CITY OF ALBUQUERQUE

RE: Wilson Warehouse 6119 Hanover Rd. NW Grading and Drainage Plan Engineer's Stamp Date: 03/25/19 Hydrology File: J10D045

Grading and Drainage Plan Resubmittal, Hydrology File J10D045

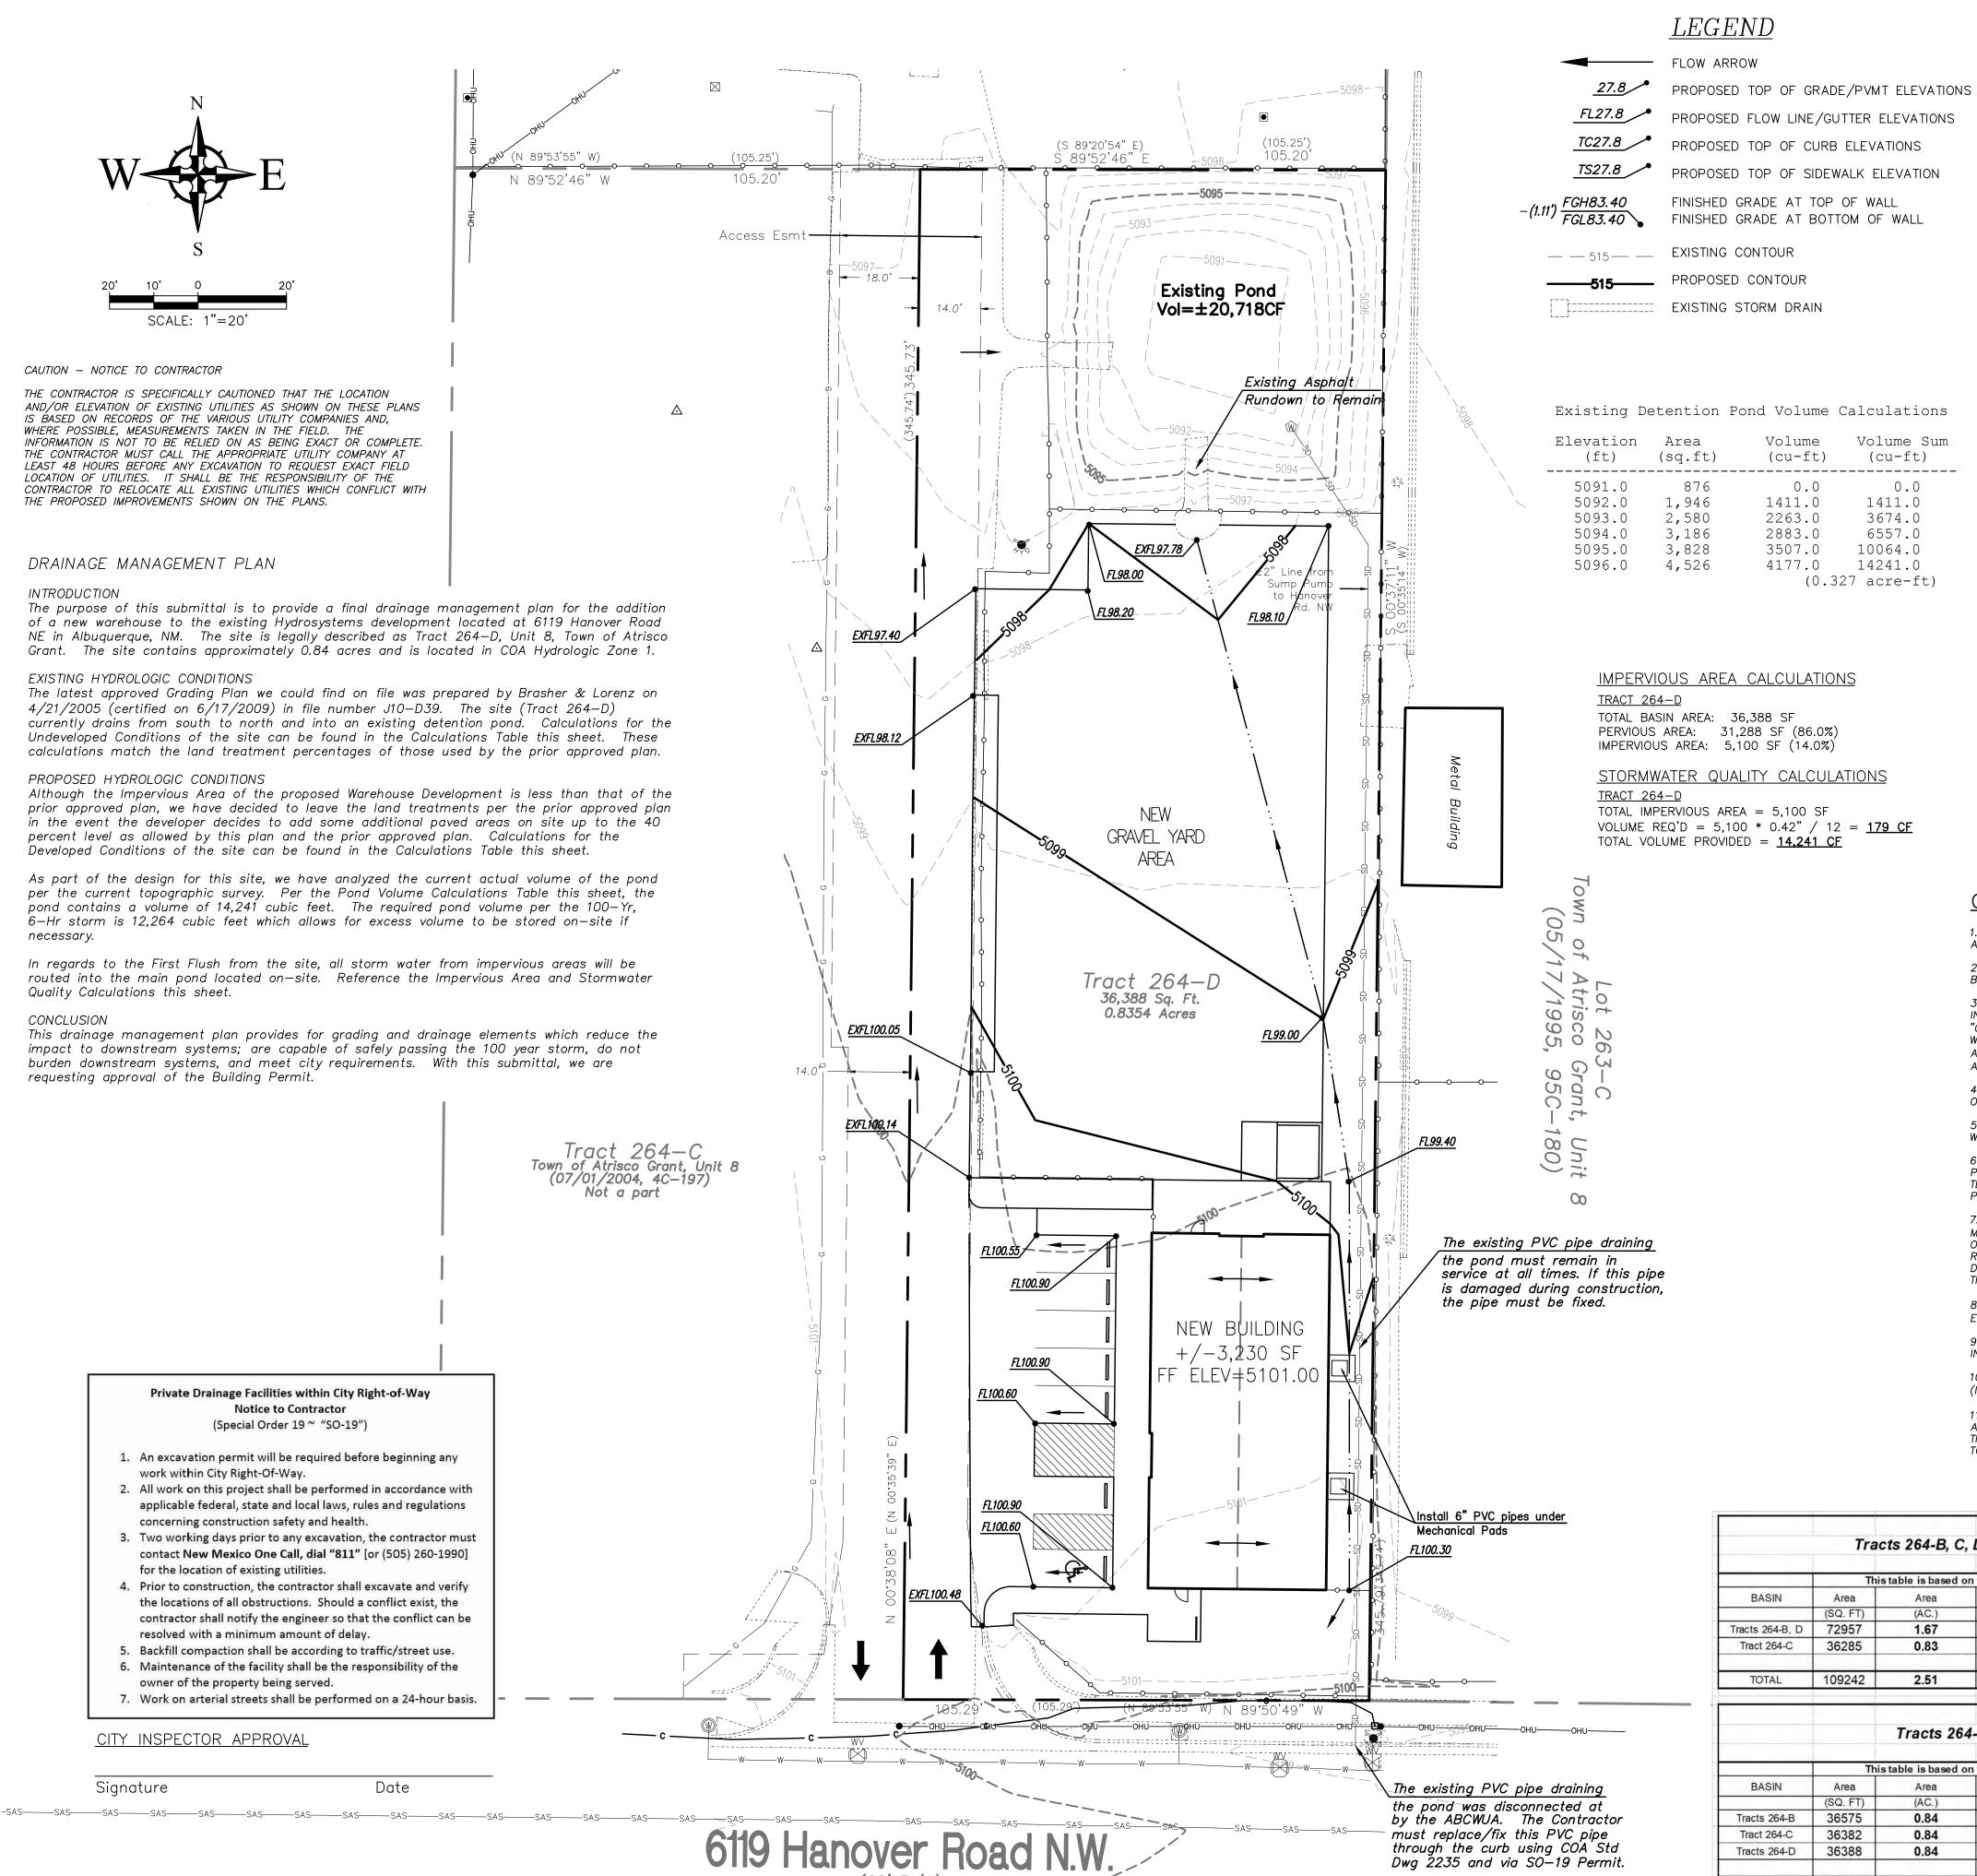
- The drainage calculations provided on the original approved plan contained some mathematical errors and did not match those as required by the DPM. We have updated the drainage basin table to match the DPM and double checked the calculations manually. The Land Treatment values for the Developed conditions match those that currently exist on site.

- 2. The note to fix the existing pipe has been added.
- 3. We have added the SO-19 permit notes and the signature line.
- 4. The note has been added to the plan.

- 5. The calculations provided on the revised plan reflect current conditions for Tracts 264-B and 264-C. Tract 264-D reflects the proposed conditions from this project. Our calculations, based directly on the DPM, show that the 100-Year, 6-Hour volume generated by the entire site is 12,264 cubic feet. The actual volume of the existing pond is 14,241 cubic feet up to elevation 5096.00; with excess capacity up to an elevation of 5097.00. Since the pond is a retention pond and capturing 100% of the flows generated by the site, no routing is required. The pump and pipe outlet previously installed was provided in order to slowly drain the pond into Hanover Rd NW after the storm has subsided.

- 6. The detention (retention) pond does not need to be enlarged; therefore, the new spillway will not be required.
- 7. A Drainage Covenant will be provided as requested prior to CO request.
